PRELIMINARY DRAINAGE REPORT FOR CANYON CREEK RANCH

revise to Final Drainage Report

> Project No. 25322.00 PCD File No. SF2434

> EXISTING DRAINAGE MAP CANYON CREEK RANCH JOB NO. 25322.00 10/10/2024 SHEET 1 OF 1

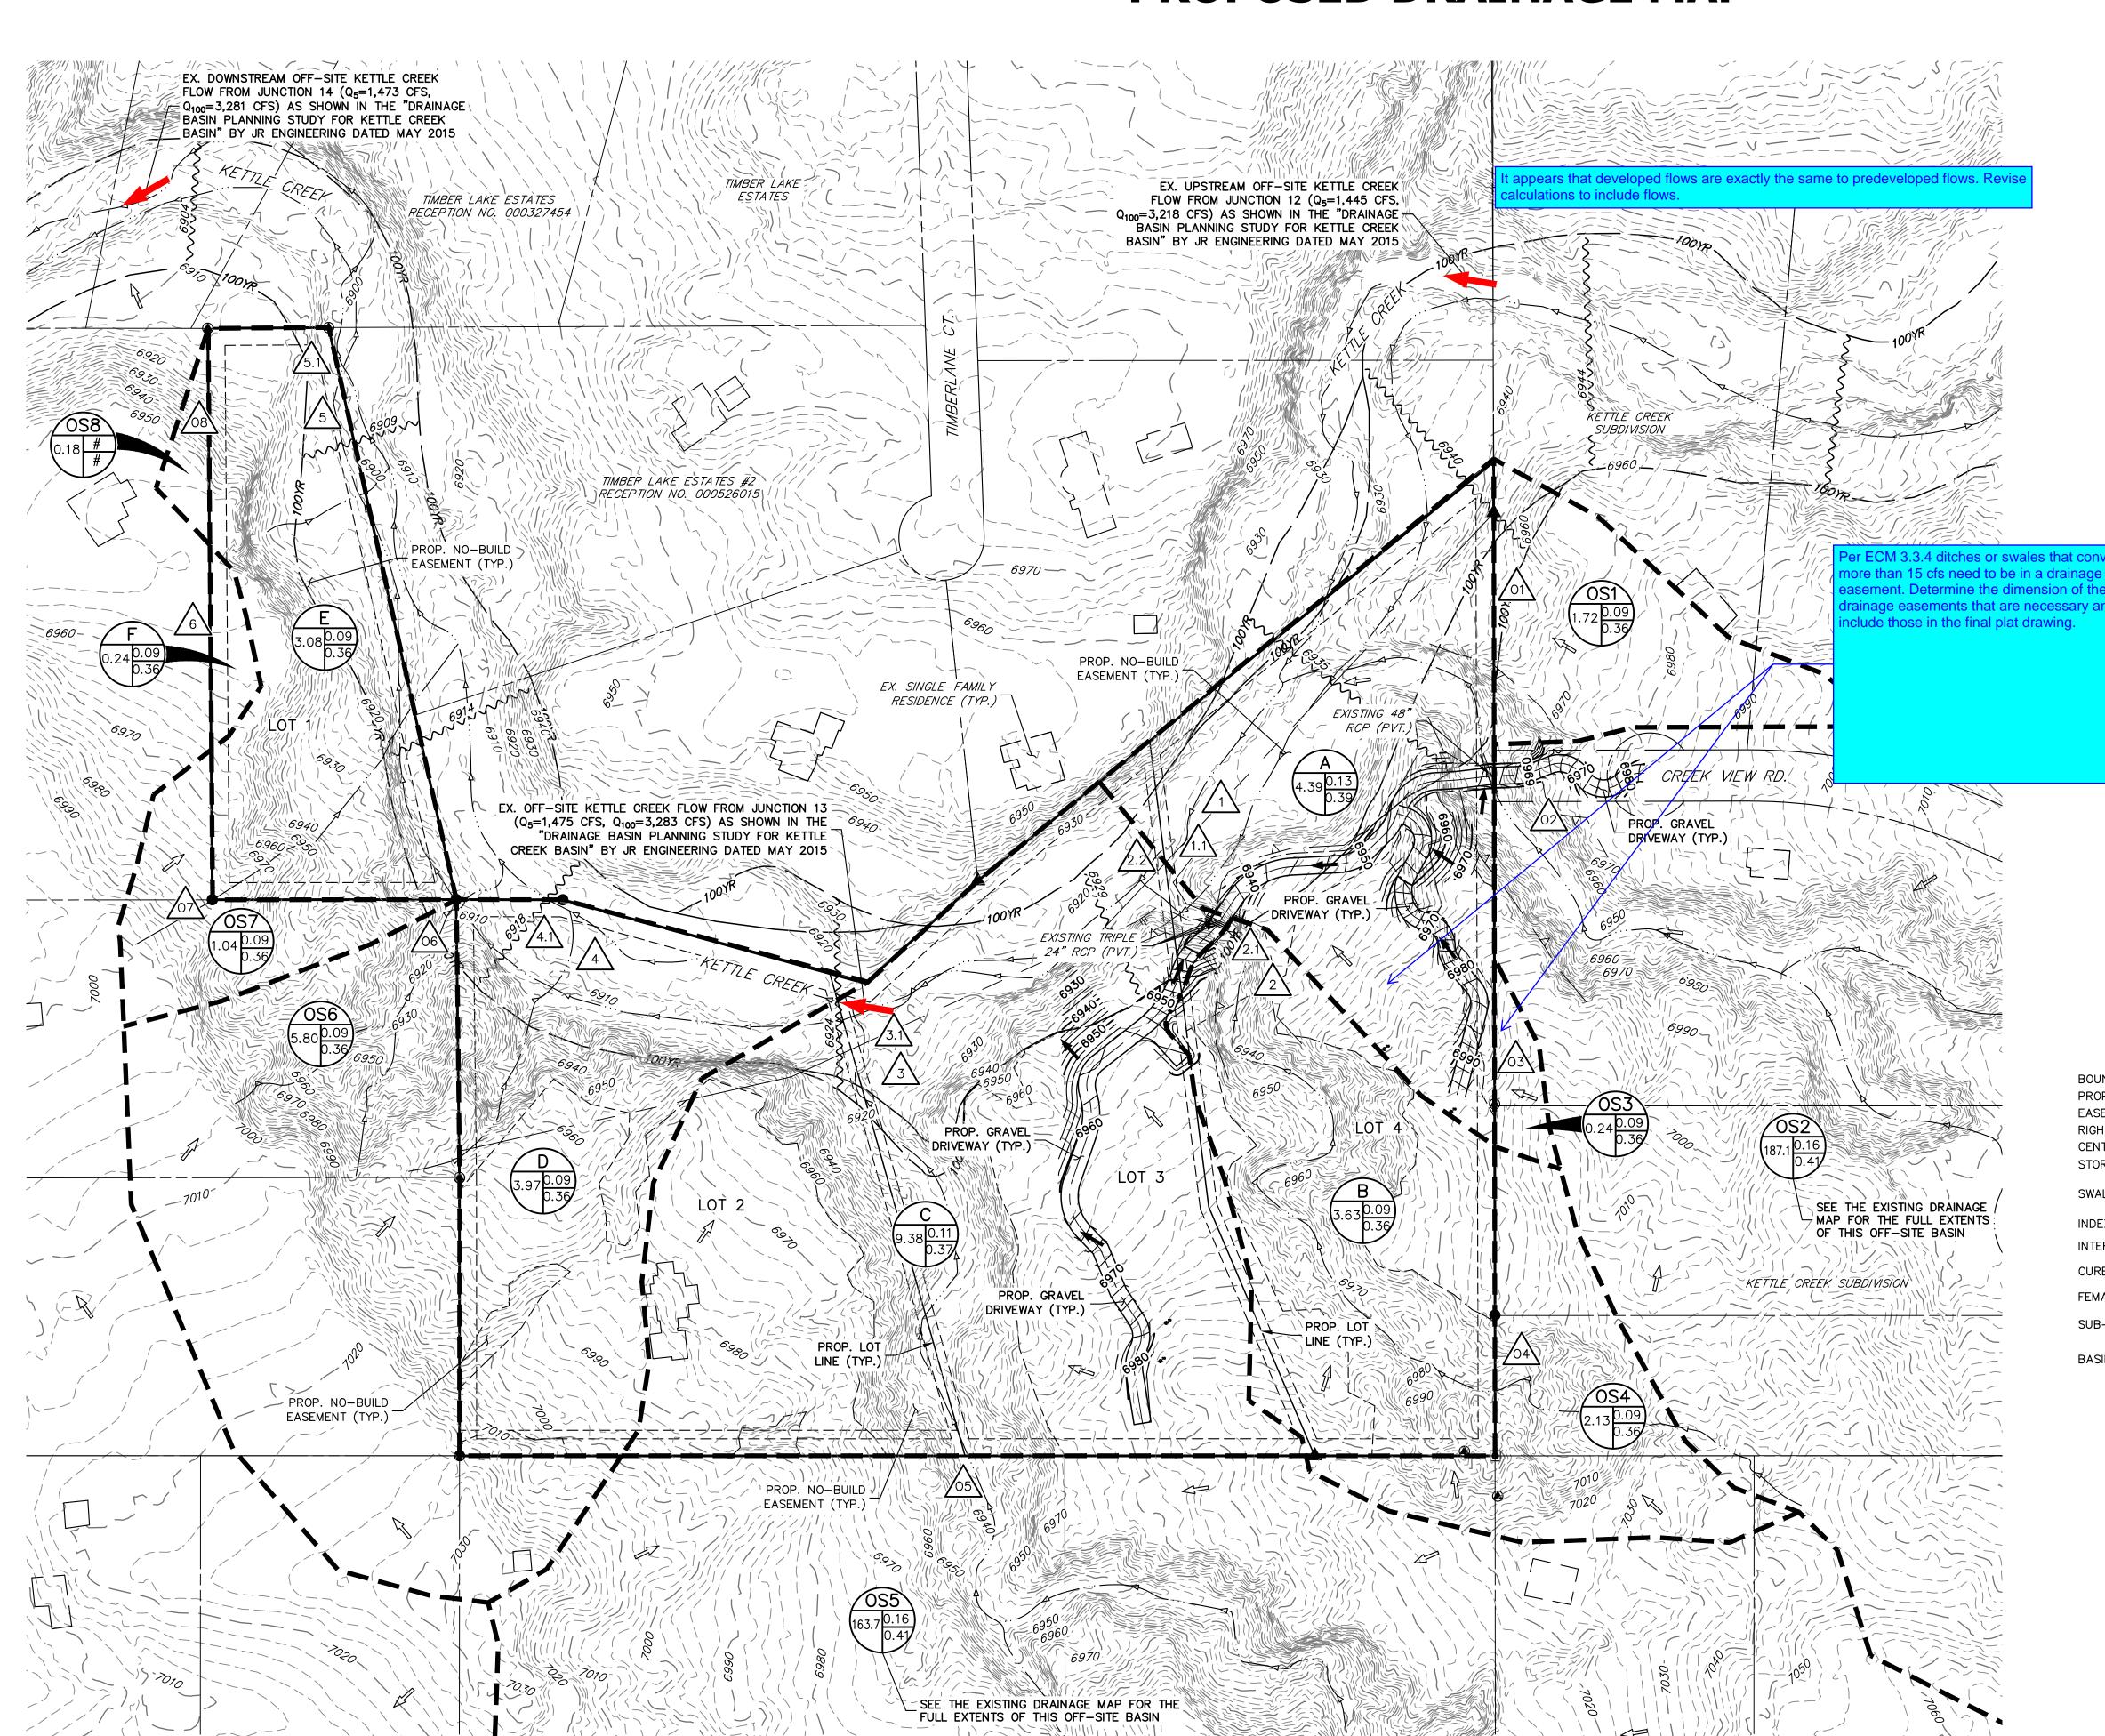
D for an exhibit showing the existing images. please label on the drainage plan

PROPOSED DRAINAGE MAP CANYON CREEK RANCH JOB NO. 25322.00 10/10/2024 SHEET 1 OF 1

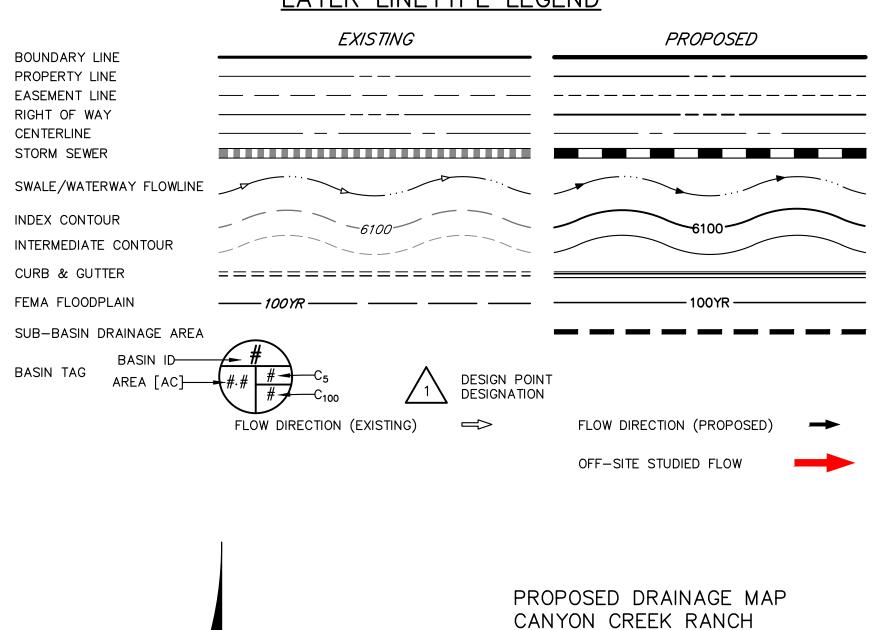
Revise developed flow calcs to include an area for the homes that will be built there. Project Name: Canyon Creek Ranch
